RE: Existing Berm Grading Revision

Upper Clear Creek Mitigation Site (UCCMS) Project

$\begin{tabular}{ll} \textbf{UCCMS Berm Revision - Downstream of BC1} \\ August 28, 2015 \end{tabular}$

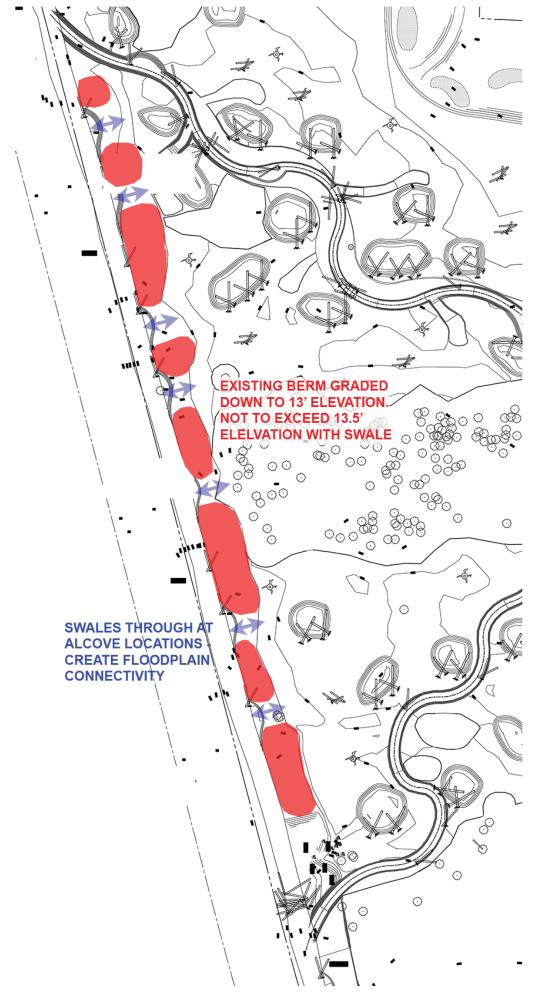
The purpose of this memorandum is to summarize excavation/grading revisions to the right bank berm of the existing channel downstream of Backwater Channel 1 (BC1). We have observed that the water surface elevation (WSE) at the downstream end of the project area is higher than anticipated likely due to a combination of higher upstream inflows and a higher water surface downstream of the project site. As such, achieving final design grades for the excavation of the berm down to 12.5 feet (MLLW) is likely not possible without significant impacts to construction methods, schedule, access, water quality, and planting plan revisions.

Over the past month the downstream WSE has been gradually increasing, not decreasing as typically encountered for summer base flows. Most interestingly, this increase has occurred with no significant measurable precipitation. The week of August 6, 2015 the downstream WSE is near 12.8 feet (MLLW), 0.3 feet above final design grades. Data collected by Herrera downstream of the site in 2010 for the WSDOT mitigation site showed the same upward summer trend, so it is highly possible the WSE will continue to be high for this summer. Field measurement by USGS at gauge #12102175 over the last 7 years suggests that tailwater conditions can vary between 0.2 to 0.6 feet at any given discharge due to the low gradient nature of the channel. As such, this "backwatered" WSE at the downstream end of the site appears to be highly variable and likely fluctuates throughout the year and from year-to-year. Based on the data, and variations we have observed during construction over the past two years, we expect ground elevations as high as 13.0 to 13.5 feet (MLLW) will support wetland conditions and vegetation.

To ensure additional floodplain connectivity between the existing channel and new constructed floodplain at lower flows, the berm grading will be revised as follows (see attached graphic):

- 1. Rough grade to elevation 13 feet with excavation material hauled away.
- 2. Periodic excavation of a swale at every alcove down to as close to elevation 12.5 feet as possible. These excavations will connect the channel to the site wetland floodplain. Each swale shall be approximately the width of the alcove's length.
- 3. Excavation from the swale may be placed on the excavated berm, provided the added material does not raise the berm above 13.5 feet elevation. (13.1-13.2 feet elevation is anticipated).
